MIXED USE DEVELOPMENT

WEST HALF STREET

REVISED DRAWING : POST HEARING SUBMISSION

District of Columbia
CASE NO.08-30B
EXHIBIT NO.34A1

GROUND FLOOR PLAN

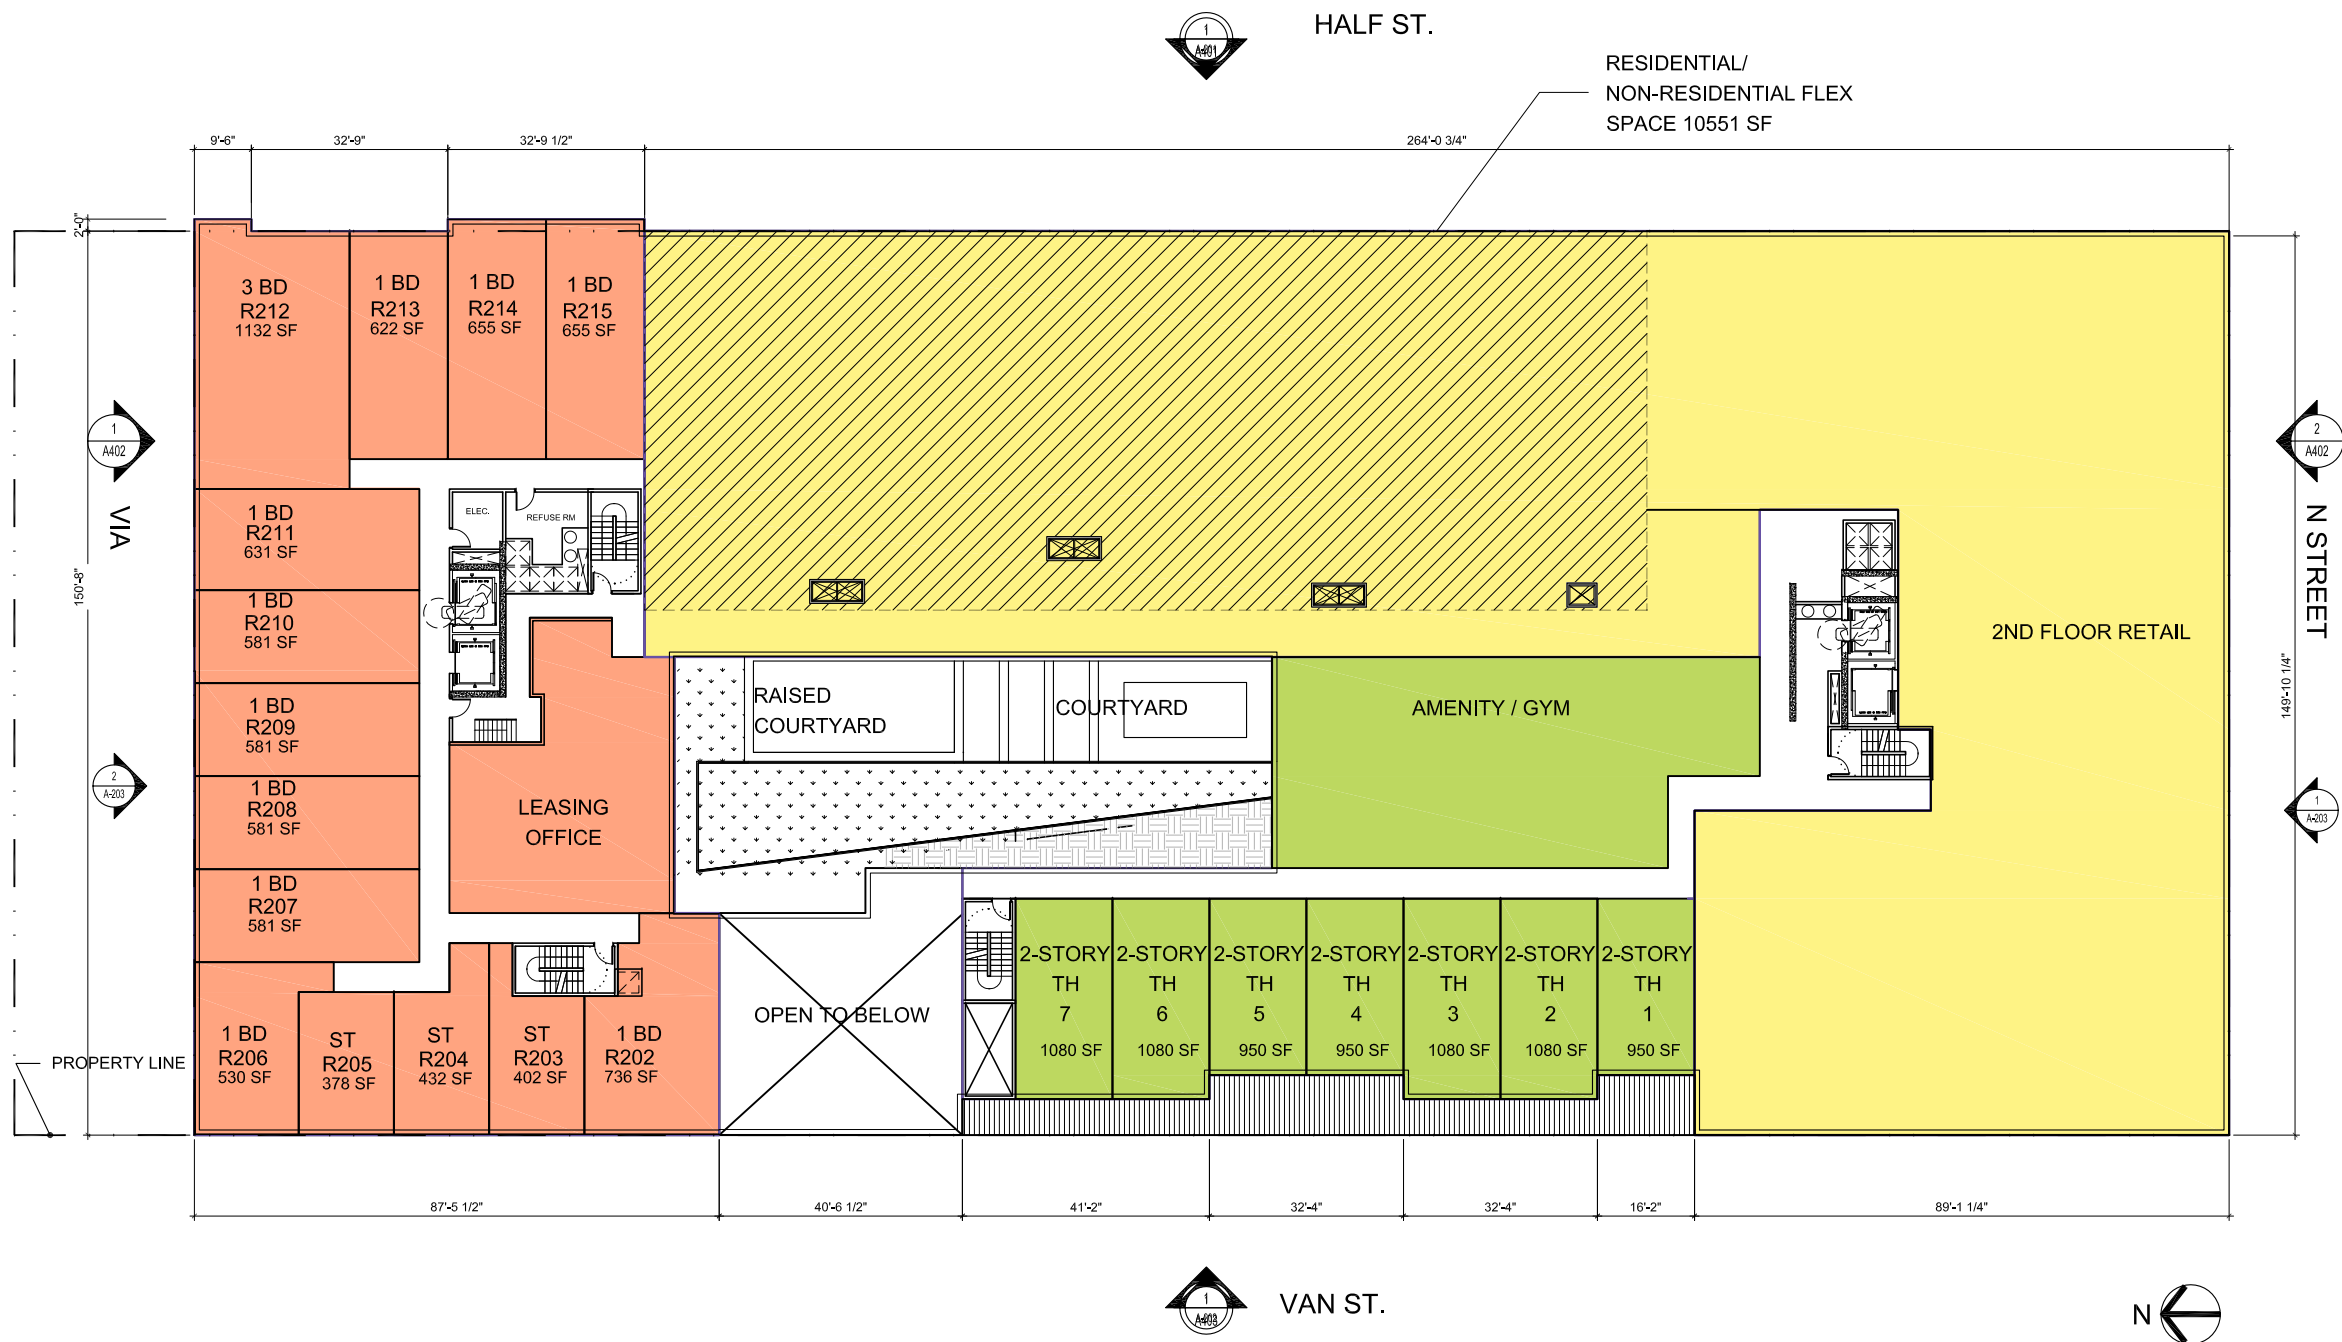
SHEET	SHEET DESCRIPTION	NARRATIVE OF REVISION 02/05/16
A103.00	SITE / ROOF PLAN	PLAN FLIPPED (NORTH POINTING LEFT), ROOF UPDATED PER CURRENT PLAN
A105.00	PROJECT STATISTICS	NUMBERS HAVE BEEN UPDATED
A106.00	MODIFICATION OF PREVIOUSLY APPROVED PLANS	PLAN FLIPPED (NORTH POINTING LEFT), NUMBERS HAVE BEEN UPDATED PER CURRENT DESIGN
A107.00	ZONING TABULATION	UPDATED PER CURRENT STATUS
A201.00	PARKING P3	PLAN FLIPPED (NORTH POINTING LEFT), NUMBER OF PARKING SPACES UPDATED
A202.00	PARKING P2	PLAN FLIPPED (NORTH POINTING LEFT), NUMBER OF PARKING SPACES UPDATED
A203.00	PARKING P1	PLAN FLIPPED (NORTH POINTING LEFT), NUMBER OF PARKING SPACES UPDATED
A301.00	GROUND FLOOR PLAN	PLAN FLIPPED (NORTH POINTING LEFT), INTERIOR LAYOUT UPDATED, HALF STREET LANDSCAPE ADDED
A302.00	2ND FLOOR PLAN	PLAN FLIPPED (NORTH POINTING LEFT), EXTERIOR WALL DIMENSIONS PROVIDED, INTERIOR LAYOUTS UPDATED PER CURRENT PROGRESS
A303.00	3RD FLOOR PLAN	PLAN FLIPPED (NORTH POINTING LEFT), EXTERIOR WALL DIMENSIONS PROVIDED, INTERIOR LAYOUTS UPDATED PER CURRENT PROGRESS
